# HISTORIC PRESERVATION REVIEW BOARD STAFF REPORT AND RECOMMENDATION

Landmark/District: Capitol Hill Historic District (x) Agenda
Address: 732 7<sup>th</sup> Street, S.E. () Consent
ANC: 6B (x) Concept

Meeting Date: February 23, 2023 ( ) New Construction
Case Number: 23-175 ( ) Demolition

Applicant Eric Goetz, with plans by Teass-Warren Architects, seeks concept review for a threestory plus penthouse rear and rooftop addition on a non-contributing building in the Capitol Hill Historic District.

*Views of 732 and the 8<sup>th</sup> Street-fronting buildings as seen from the through-block alley*

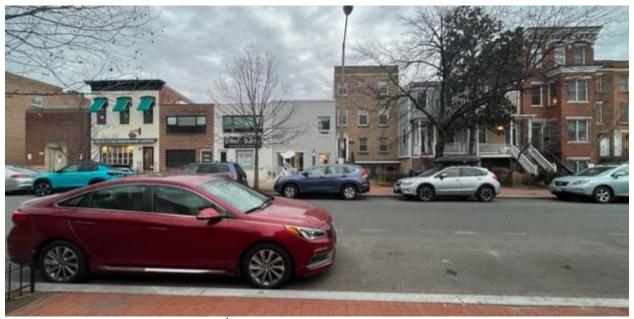
The rear elevation and partial views of the detached side elevation will be visible from 8<sup>th</sup> Street because of the through-block alley. This visibility is also true for the rear addition the Board approved on 8<sup>th</sup> Street, as seen in the below photograph. In previous cases regarding rear additions and alley buildings, the Board has had concerns about light-pollution and visibility where large fenestration is shown at the alley. This concern could be addressed by reducing the size of the large window shown on the first story rear to reduce the amount of light that will be visible at the alley and from 8<sup>th</sup> Street.
